**CERTIFICATE OF APPROPRIATENESS**

**Property:** 1038 W Temple, lot 10, block 129, North Norhill Subdivision. The property includes a historic 1,486 square foot, one-story wood frame single-family residence and a detached garage situated on a 5,000 square foot (50' x 100') corner lot.

**Proposal:** Alteration – Replace existing wood front door and frame with a new wood door in the same opening. A non-original aluminum storm door will also be removed.

**Recommendation:** Denial - does not satisfy criteria 1, 4 & 9

**EDGE DETAIL**

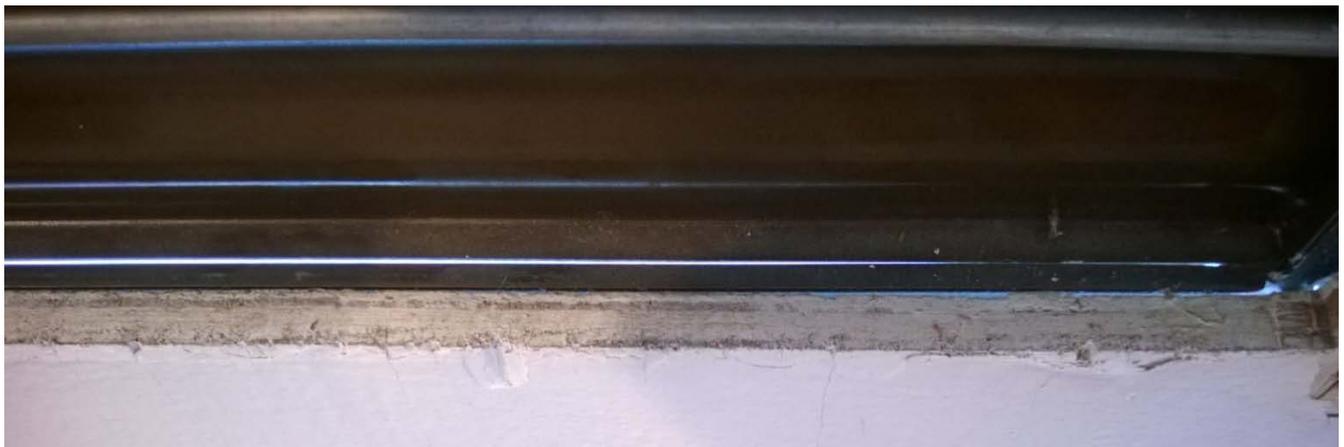
| <input type="checkbox"/>            | <input checked="" type="checkbox"/> | <input type="checkbox"/>            | (1)                  | The proposed activity must retain and preserve the historical character of the property;<br><i>The front door is one of the major elements of the structure's street façade and should not be removed.</i>   |                            |
| <input type="checkbox"/>            | <input checked="" type="checkbox"/> | <input type="checkbox"/>            | (4)                  | The proposed activity must preserve the distinguishing qualities or character of the building, structure, object or site and its environment;<br><i>The front door is one of the major elements of the structure's street façade and should not be removed.</i>  |                            |
| <input type="checkbox"/>            | <input checked="" type="checkbox"/> | <input type="checkbox"/>            | (9)                  | The proposed design for any exterior alterations or addition must not destroy significant historical, architectural or cultural material and must be compatible with the size, scale, material and character of the property and the area in which it is located;<br><i>The front door is a major element of the street façade and constitutes significant historic material. Though the door has been altered with new glass, mail slot and deadbolt, it has not been altered beyond reasonable repair.</i> |                            |
